HISTORIC AND DESIGN REVIEW COMMISSION

HDRC CASE NO: 2025-105
ADDRESS: 517 WICKES
LEGAL DESCRIPTION: NCB 2916 BLK 5 LOT 17
ZONING: RM-4, H
CITY COUNCIL DIST.: 1
DISTRICT: King William Historic District
APPLICANT: Stephanie FLORES
OWNER: Stephanie FLORES/FLORES STEPHANIES & JOE MARK
TYPE OF WORK: 2-story rear accessory structure construction
APPLICATION RECEIVED: April 23, 2025
60-DAY REVIEW: June 22, 2025
CASE MANAGER: Bryan Morales
REQUEST:

The applicant is requesting a Certificate of Appropriateness for approval to construct an approximately 950 sf rear 2-story accessory structure with a garage.

① First Floor
1/4" = 1'-0"

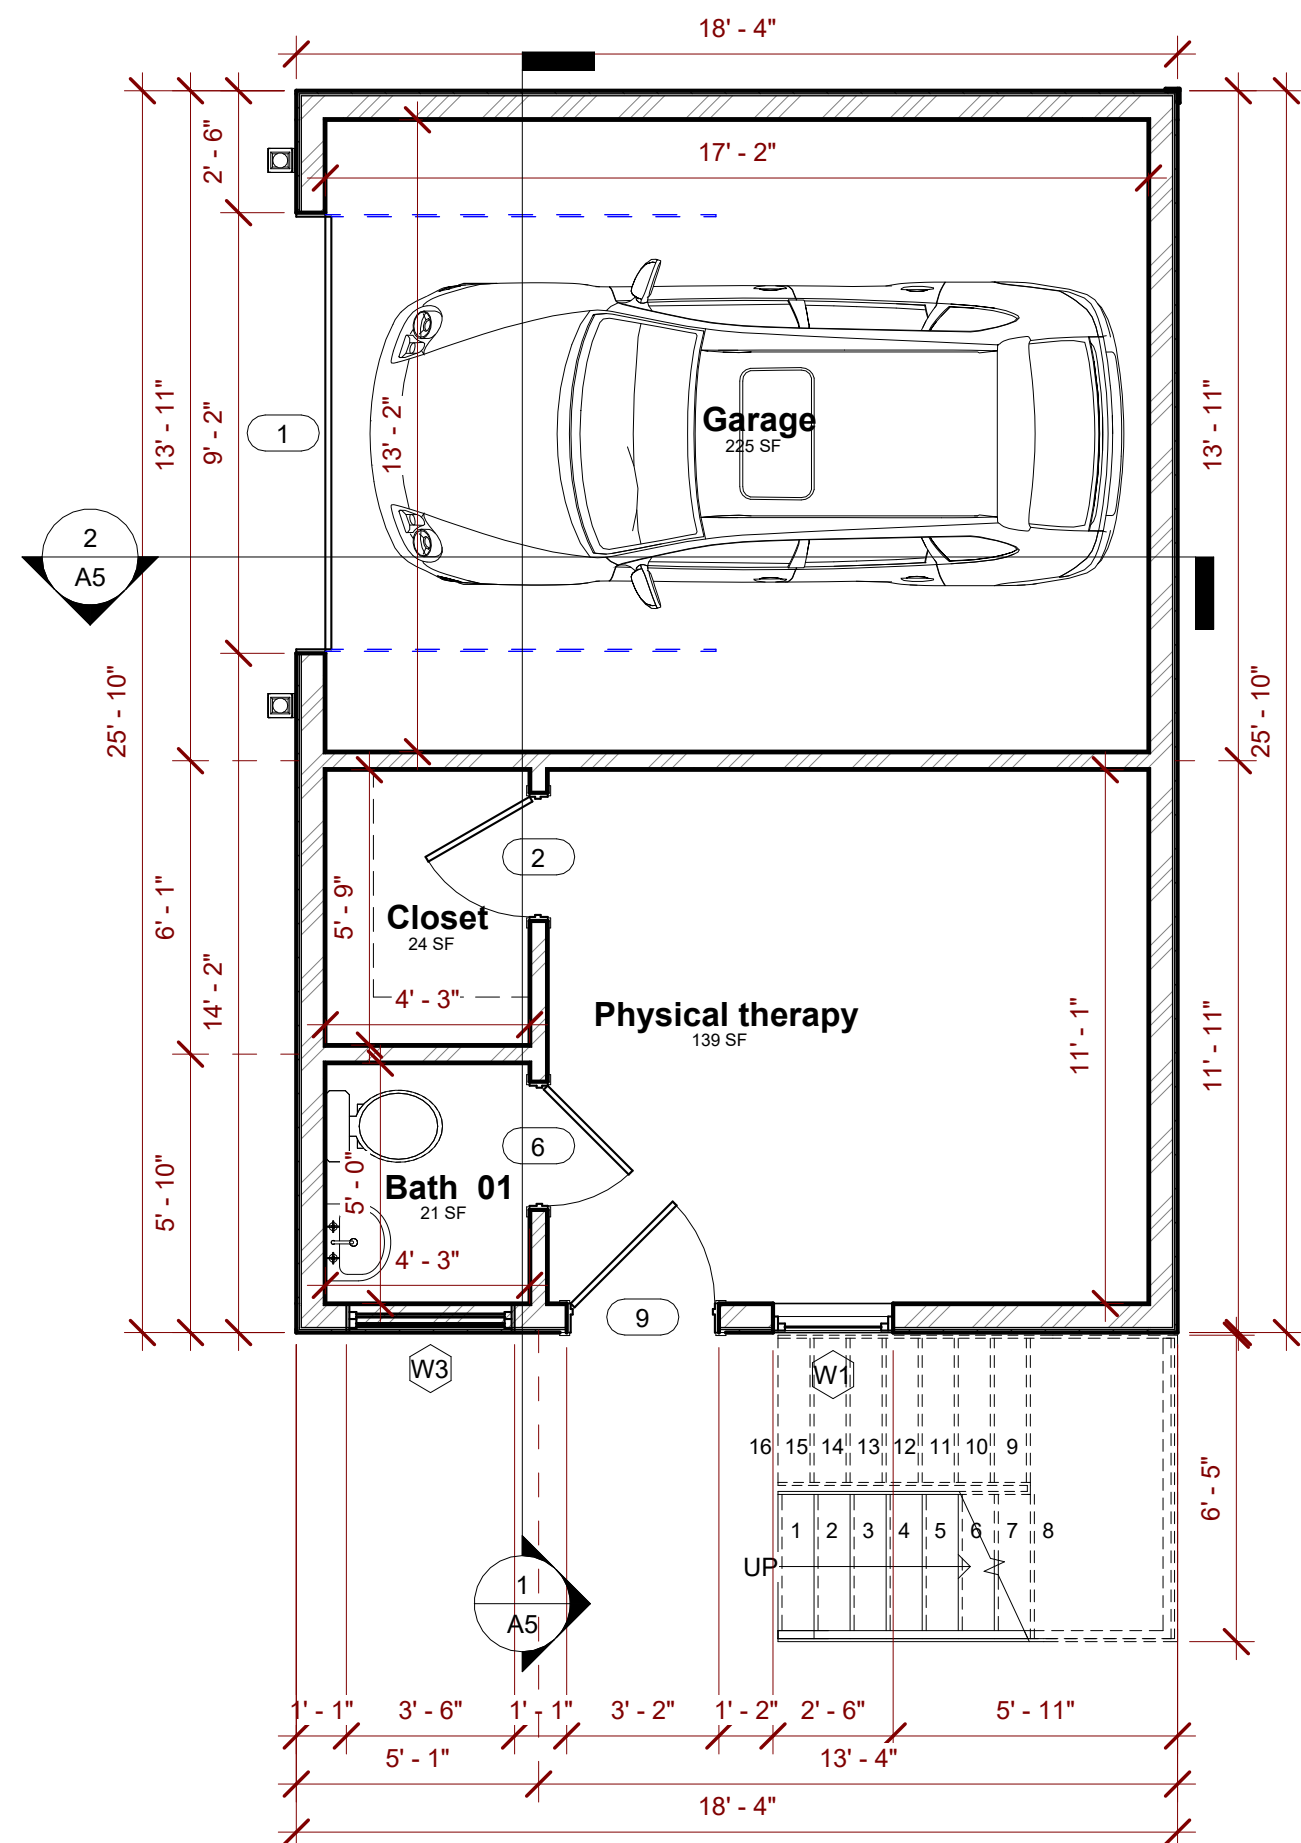
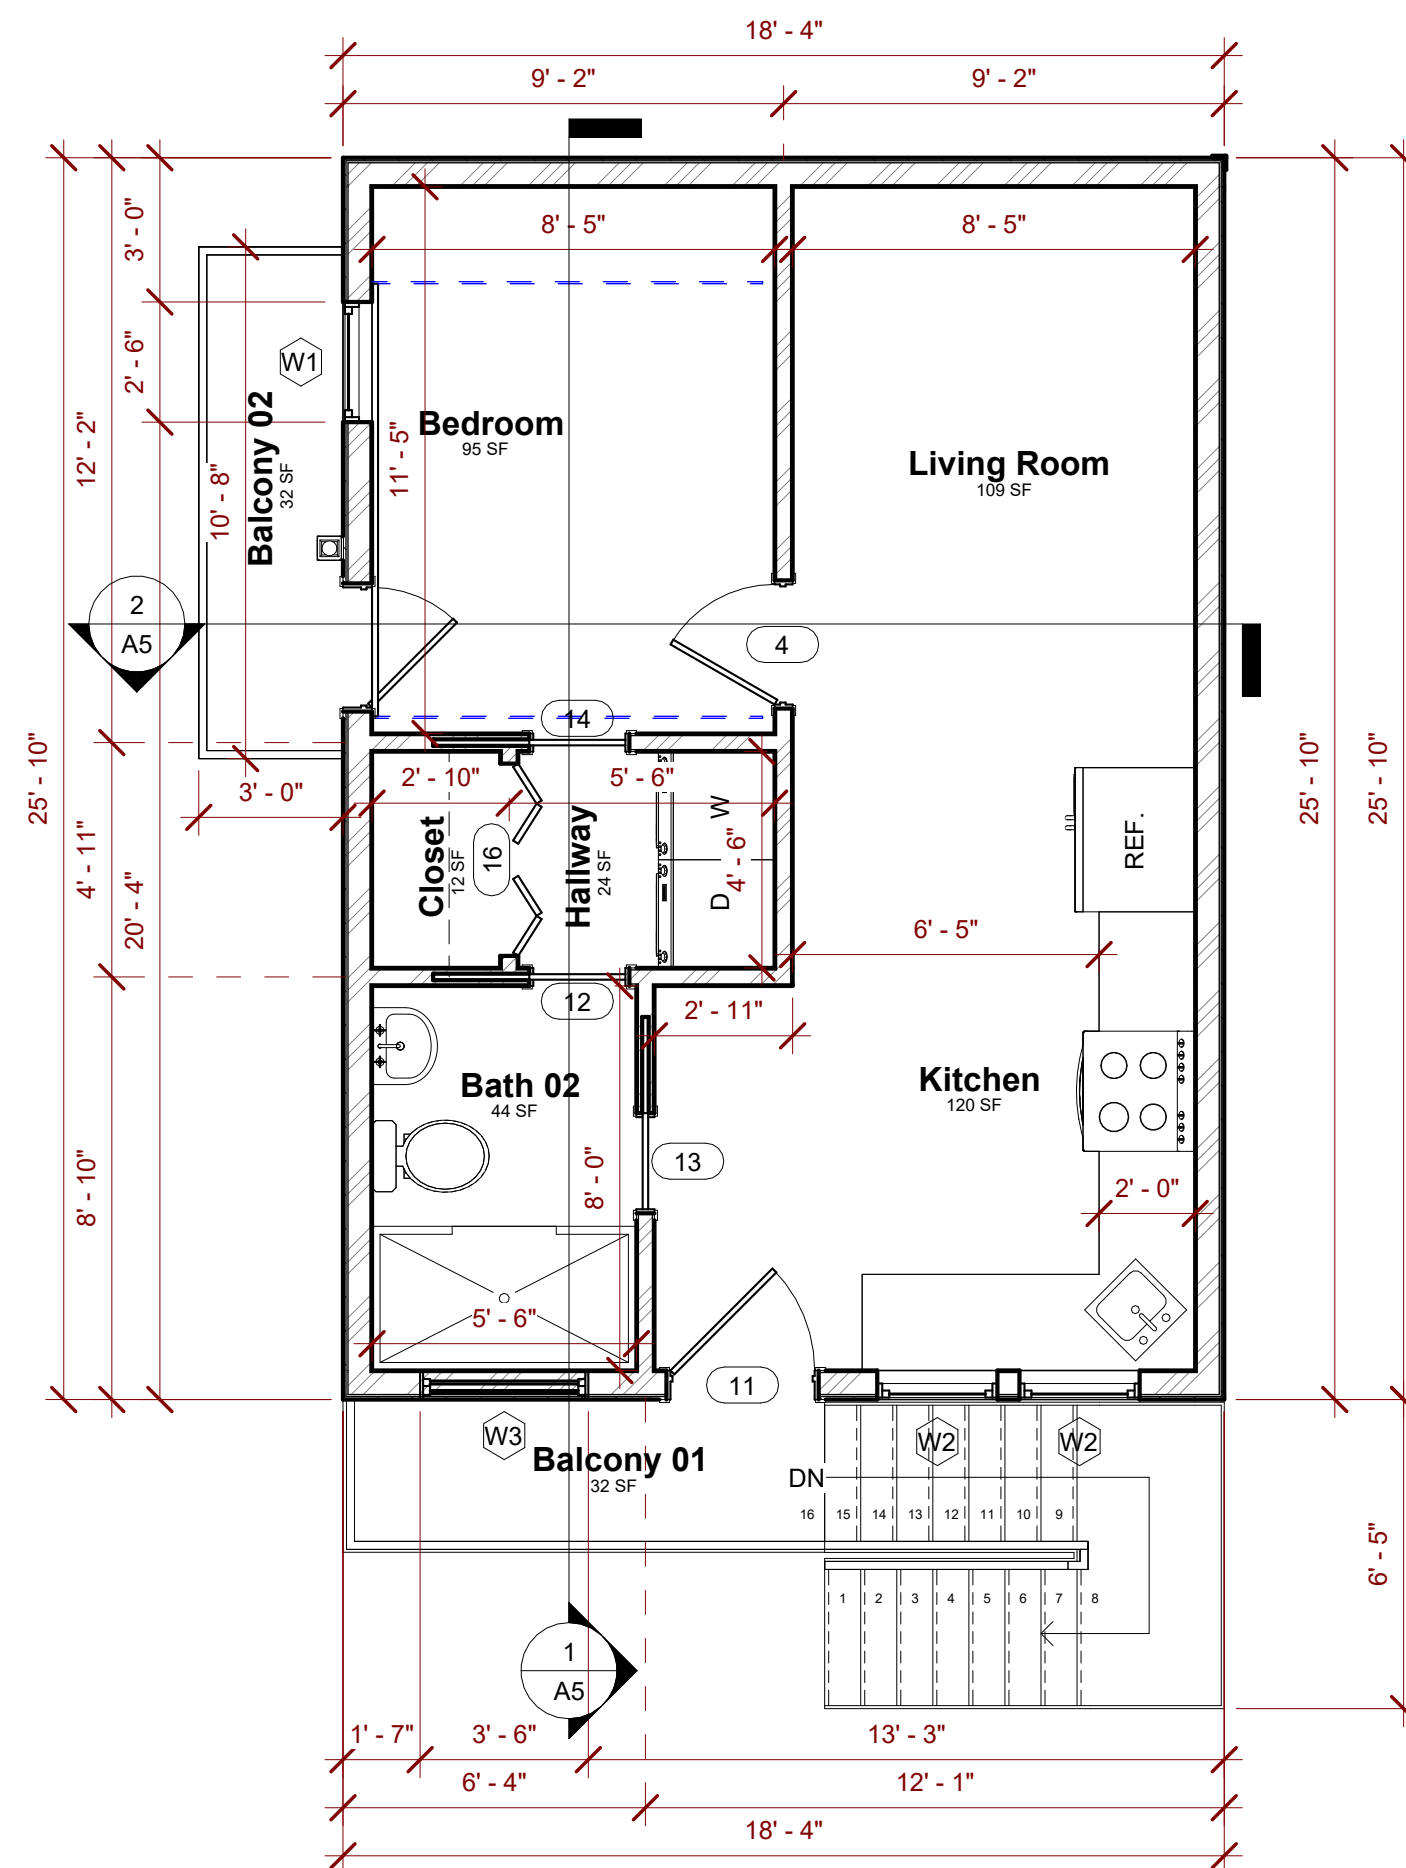
- j. ARCHITECTURAL DETAILS (FENESTRATION PATTERN) – The applicant is requesting approval to install one twelve-lite clerestory window, one door, and two one-over-one windows on the south façade’s second floor; one twelve-lite clerestory window, one door, and one one-over-one window on the south façade’s first floor; one four-over-four window and door on the west façade’s second floor; and one 9’2” wide garage door on the west façade’s first floor. New Construction 2.C.i. related to window and door openings stipulates to incorporate window and door openings with a similar proportion of wall to window space as typical with nearby historic facades. Staff finds the proposed fenestration pattern generally appropriate; however, the applicant should incorporate a consistent window style for the proposed rear accessory structure.

JF: I agree with MS. If you modify the width, it might make lowering the height of the structure more difficult. Generally, the variance, material, window placement, etc. looks like it's going in the right direction. Can we see the floor plan? SF: The second floor is pretty small. I can ask my architect to lower the height. JF: Well if you keep the 8' ceiling height on the 2-floor and lower the height, the slope will be different than the main structure. If the end walls of top walls of the 2-floor, if that wall height was 7', and the wall height at the shower and kitchen was 7', so inside the living spaces if you wanted more ceiling height, you could follow the interior ceiling beams. Try keeping the pitch of the roof the same and lowering the height. You can take a look at the upper floor; the end walls could be 6'6" even or 6'8". I think things like this will bring the whole roof down.

SF: To summarize, I am going to try and lower the 2nd floor, lower the roof.
